Nabholz Construction - Lenexa 17300 W 116th Street Lenexa, Kansas 66219 P: (913) 393-6500 **Project: 08-25-3311 HCA LSMC CAMPUS EXPANSION**2100 SE BLUE PARKWAY

RFI #023: DietEx Footings and Columns

EVEL 1 FOUNDATION PLAN

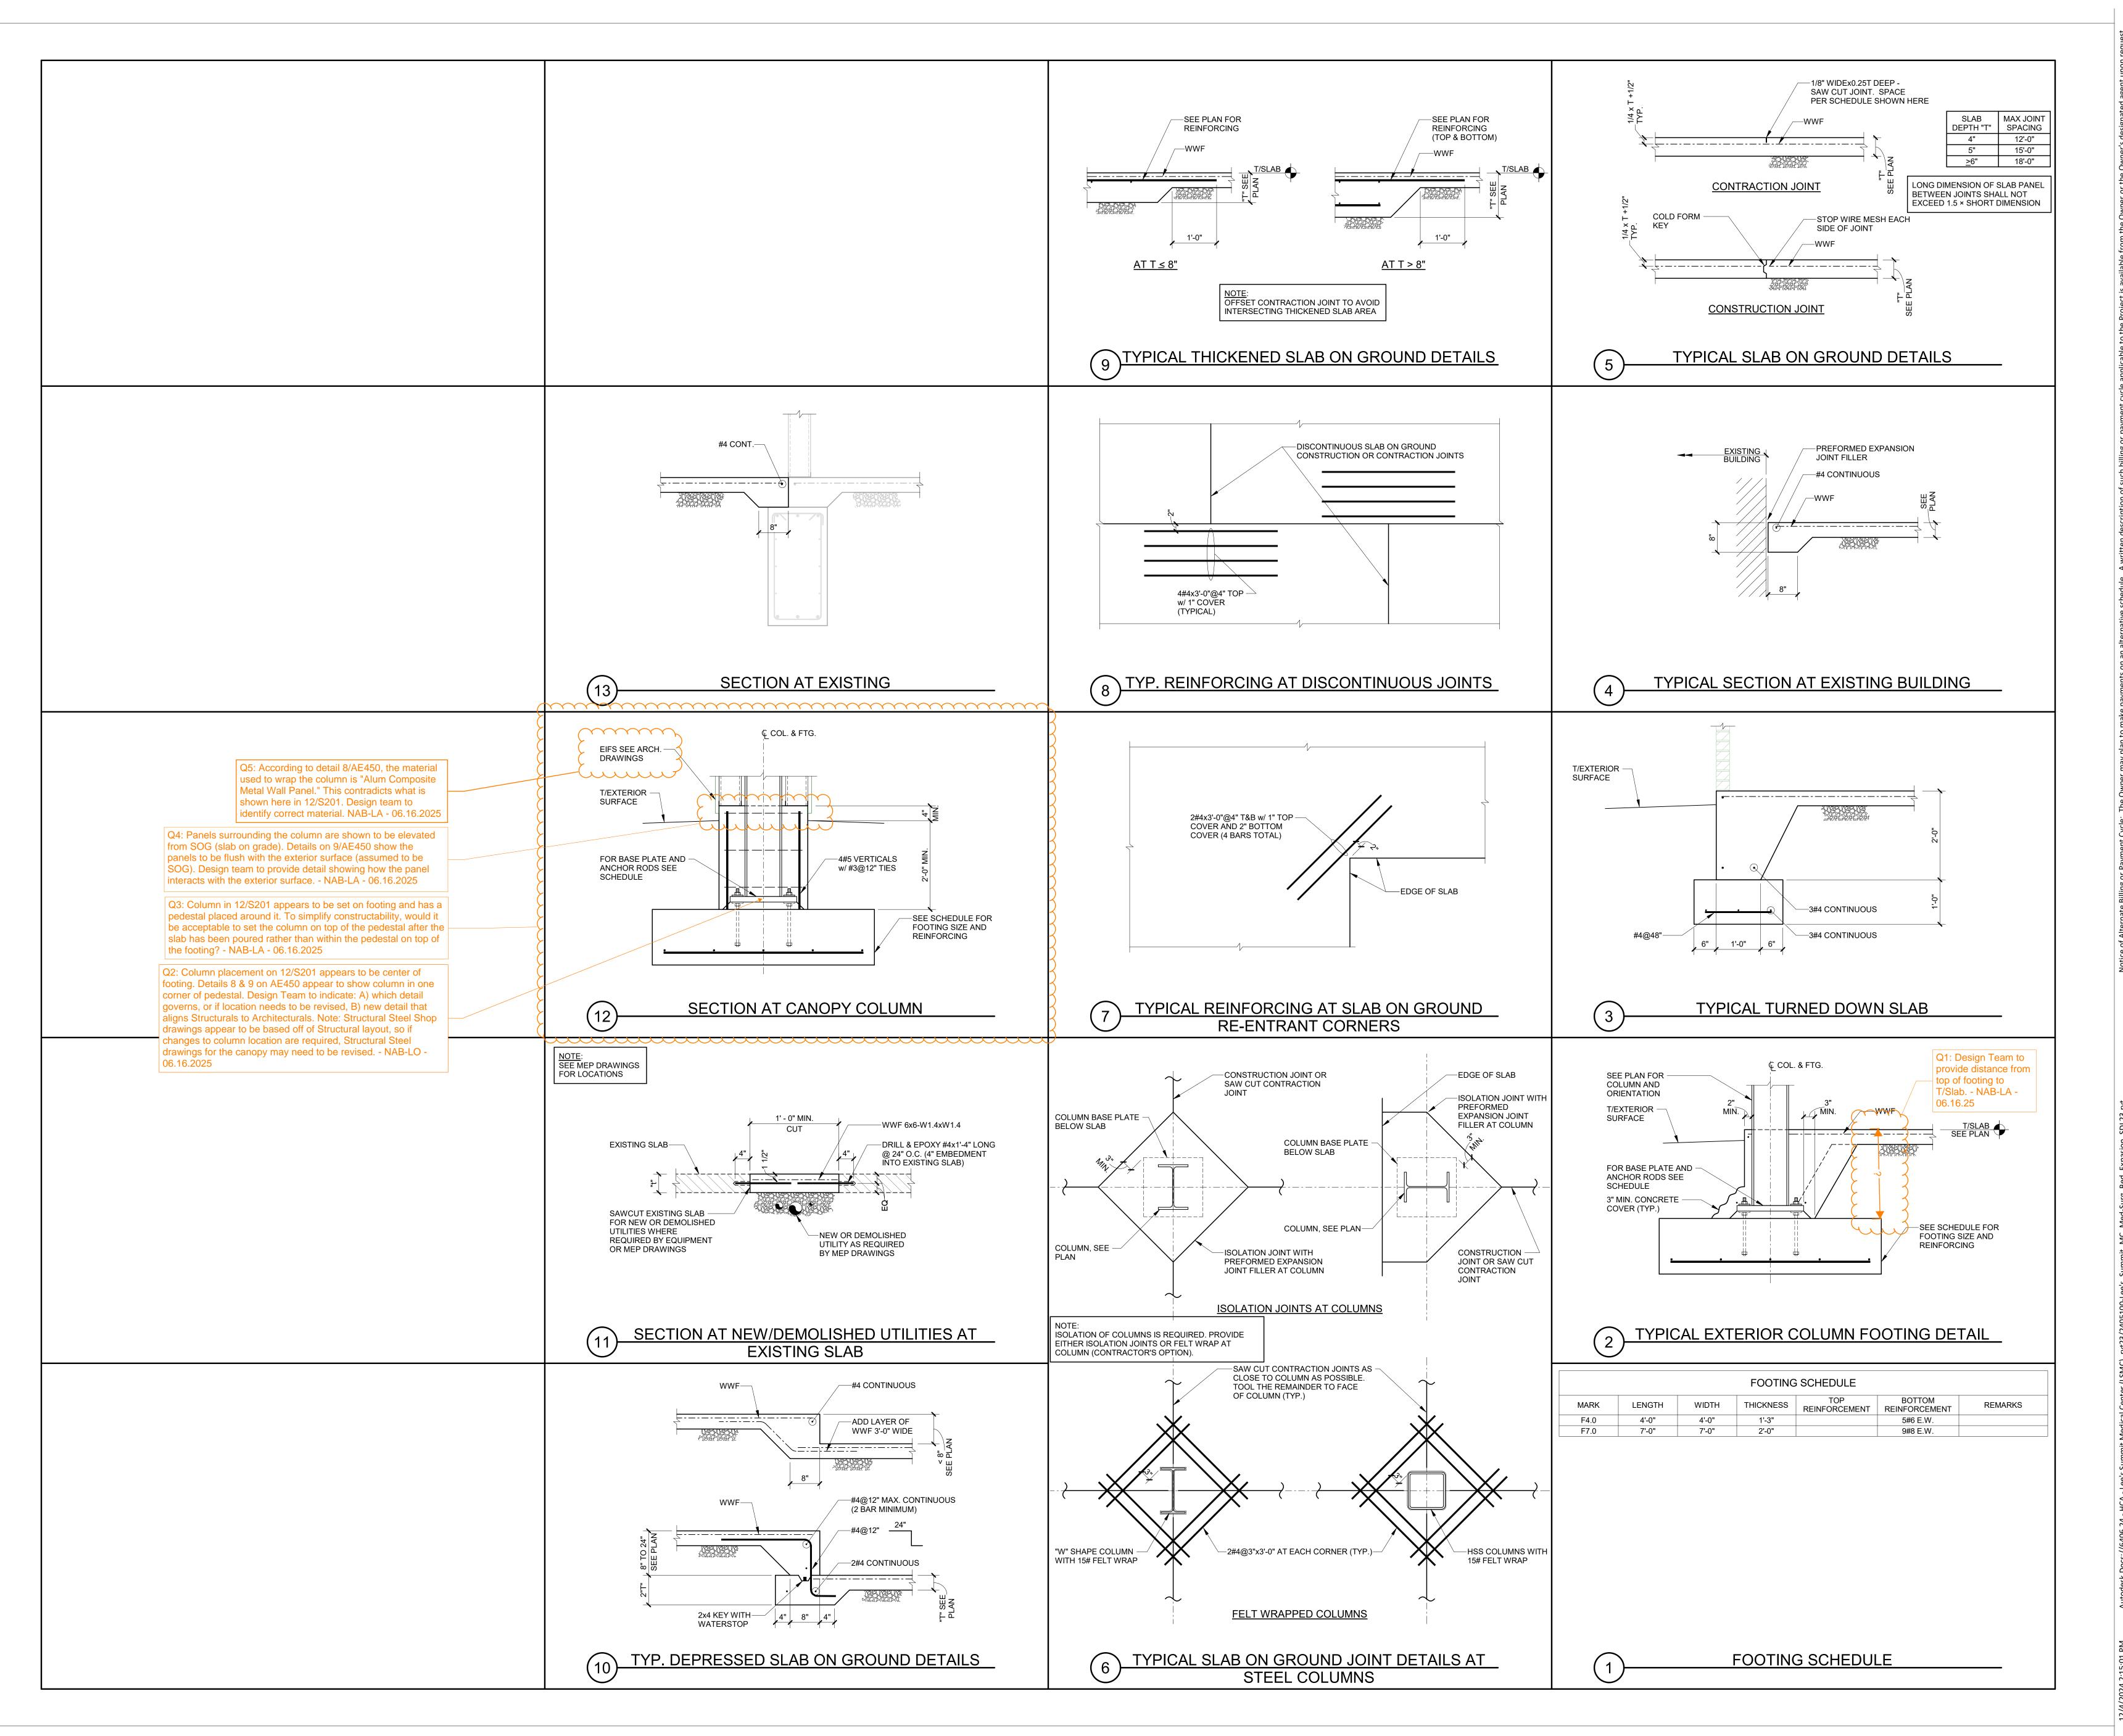
Question	Question from Luke Arbanas Nabholz Construction Corporation on Monday, Jun 16, 2025 at 10:54 AM CDT Q1: Design Team to provide distance from top of footing to T/Slab.  Q2: Column placement on 12/S201 appears to be center of footing. Details 8 & 9 on AE450 appear to show column in one corner of pedestal. Design Team to indicate: A) which detail governs, or if location needs to be revised, B) new detail that aligns Structurals to Architecturals. Note: Structural Steel Shop drawings appear to be based off of Structural layout, so if changes to column location are required, Structural Steel drawings for the canopy may need to be revised.  Q3: Column in 12/S201 appears to be set on footing and has a pedestal placed around it. To simplify constructability, would it be acceptable to set the column on top of the pedestal after the slab has been poured rather than within the pedestal on top of the footing?  Q4: Panels surrounding the column are shown to be elevated from SOG (slab on grade). Details on 9/AE450 show the panels to be flush with the exterior surface (assumed to be SOG). Design team to provide detail showing how the panel interacts with the exterior surface.  Q5: According to detail 8/AE450, the material used to wrap the column is "Alum Composite Metal Wall Panel." This contradicts what is shown here in 12/S201. Design team to identify correct material.

- 1. Drawings referenced in the RFI are not the current drawings. Ref. Sheet notes on S121. Footings are 2ft below FFE.
- 2. Columns are located as shown on plan. Center of column is center of footing. Pedestals are as required for architectural finish. Any steel below grade that does not have 2" min. concrete cover shall be protected by mastic coating.
- 3. No.
- 4. Architect to confirm.
- 5. Provide Aluminum Composite Metal Wall Panel per the Architect drawings.
